ALAMEDA COUNTY
HEALTH CARE SERVICES

Subject: Fuel Leak Case RO0000405, Chevron Station #9-8341, 3530 MacArthur Blvd.,
Oakland, CA 94619

Alameda County Environmental Health (ACEH) staff has reviewed the case file for the subject site including the September 16, 2004 Investigation Workplan by Cambria. The work plan proposes one additional up-gradient boring and one additional down-gradient monitoring well to further investigate the lateral and vertical extent of the hydrocarbon and oxygenate plume originating from this site. We concur with the work proposed, however, we believe that additional investigation, beyond that proposed, is required to progress to site closure. We request that you address the following technical comments when performing this work and submit the technical report requested below.

FIGURE
2

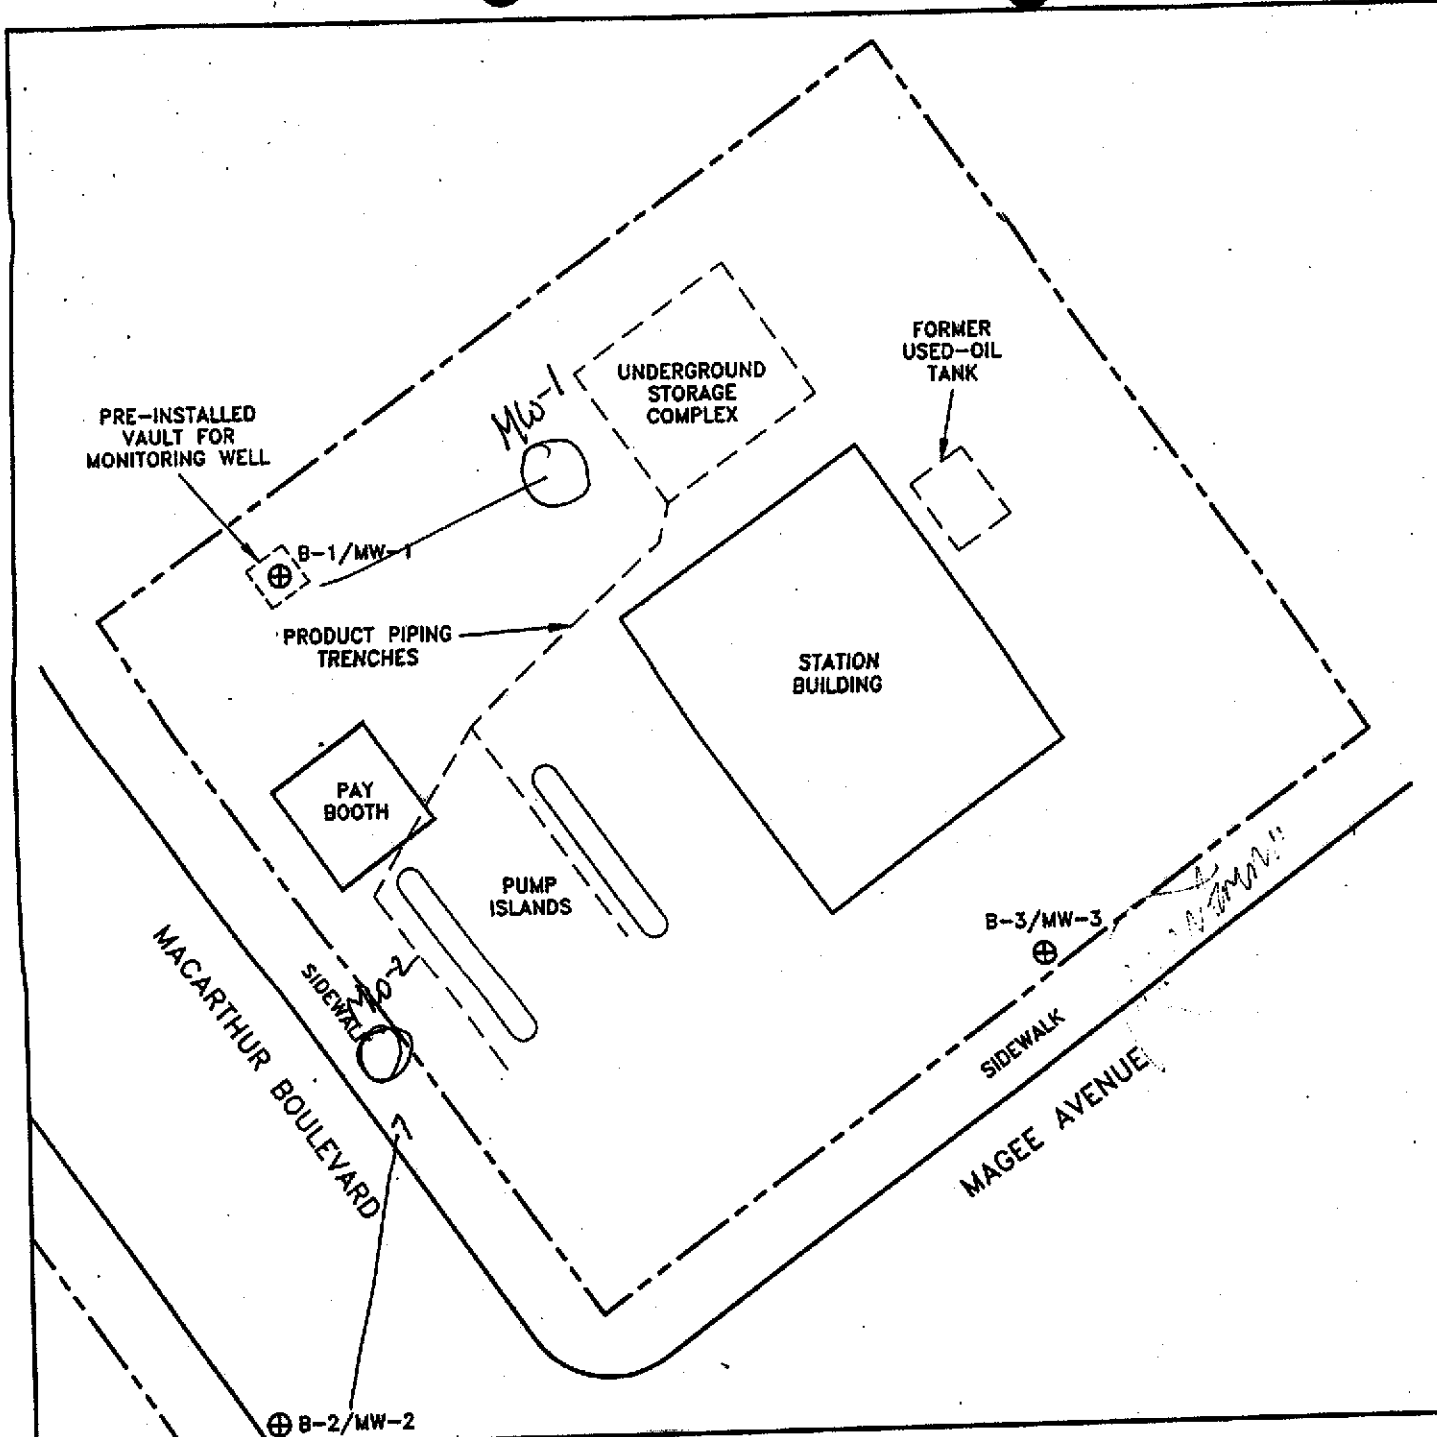
1. You had mentioned that by locating the wells further apart from each other, a larger potentiometric surface plane will be created and this will provide a better approximation of the direction of groundwater. This may be true in instances where the wells are located less than 40 to 50 feet from each other. However, since the proposed location of the monitoring well, MW-2 is nearly 120 feet from the pump island, this Department had recommended that the well be located within 20 to 25 feet of the pump island and this modification will not bring the wells closer than 50 feet to each other. If the monitoring wells are placed significantly apart from each other, the measured gradient may not be representative of the local conditions and which in some instances differ from the regional groundwater gradient. Also, this Department recommends moving monitoring well, MW-1 to a location closer to the underground storage tank area as this may give indication to any past or existing leaks/spills in this area. I have enclosed a copy of the site map with the recommended location for monitoring wells, MW-1 and MW-2.

4. Placing a downgradient well more than 100 feet away from the likely source of contamination may not provide enough data to this Department to make decisions regarding closure. As you may know, this Department usually evaluates the groundwater conditions for reasons of closure using at least 4 quarters of groundwater monitoring data. However, without data from a monitoring well located within 30 feet from the main source of contamination, it is difficult to make decisions regarding closure, regardless of the concentrations found in other monitoring wells. Hence, it is to Chevron's benefit to re-locate monitoring wells, MW-1 and MW-2 to obtain data that can be used by this Department to evaluate the risk to public health and groundwater quality due to any contamination present on site.

Hopefully, this response provides clarification to your comments. **Please provide a modified workplan to this Department within 15 days from the receipt of this letter.** If you have any questions, you can reach me at (510) 567-6764.
